**CITY OF KELOWNA**  
**MEMORANDUM**

**Date:** December 17, 2019  
**File No.:** Z19-0132  
**To:** Suburban and Rural Planning (TC)  
**From:** Development Engineer Manager (JK)  
**Subject:** 925-929 McCurdy Rd

A1 – I2

**SITE PLAN N.T.S.**

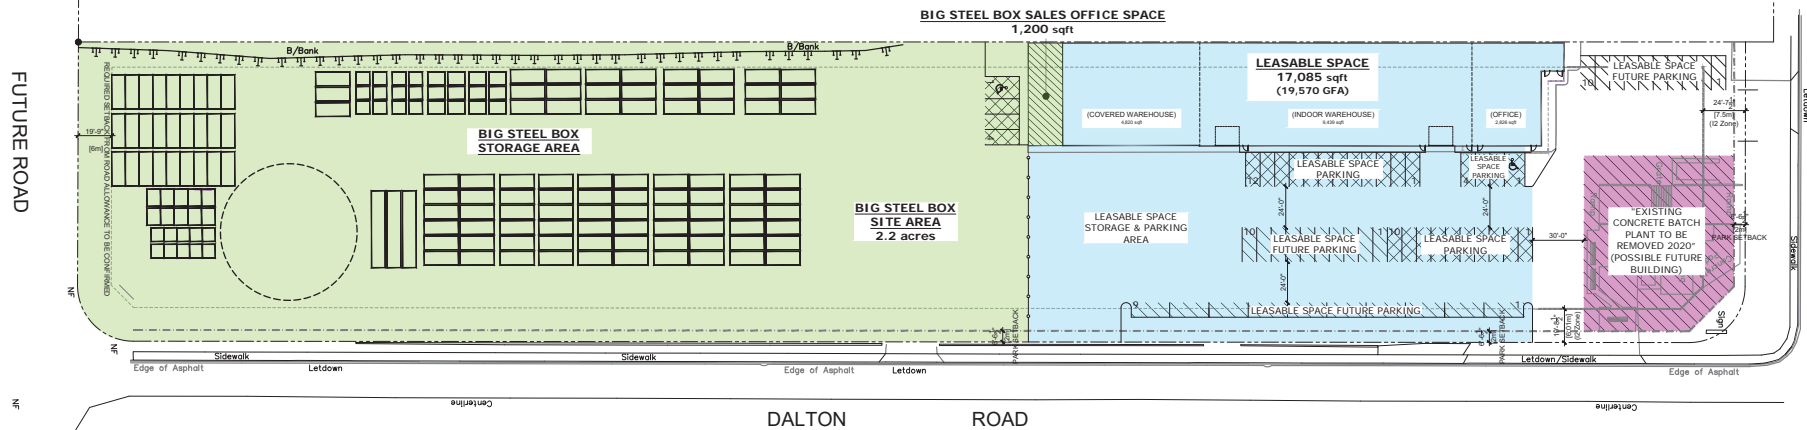
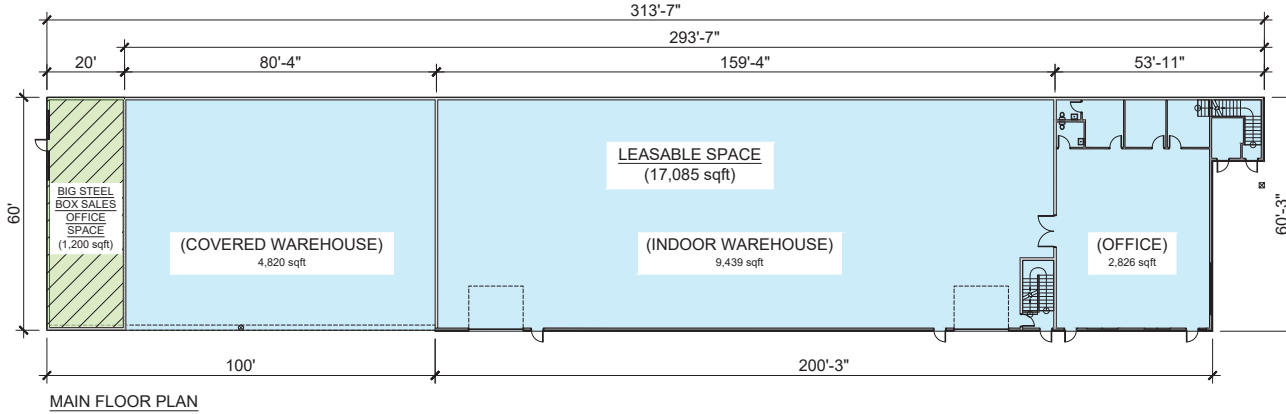
- c) Existing two driveway letdowns on McCurdy Rd must be removed at the next permit application and must comply with bylaw 7900.

- d) Dalton Rd fronting this development must be upgraded to a Major Collector standard including irrigated landscaped boulevard. Existing driveways along Dalton Rd must follow bylaw 7900. Any unused driveway letdowns must be removed.
- e) South road upgrades fronting this development has been addressed in servicing agreement and LOC paid in the amount of **\$119,764.50**.
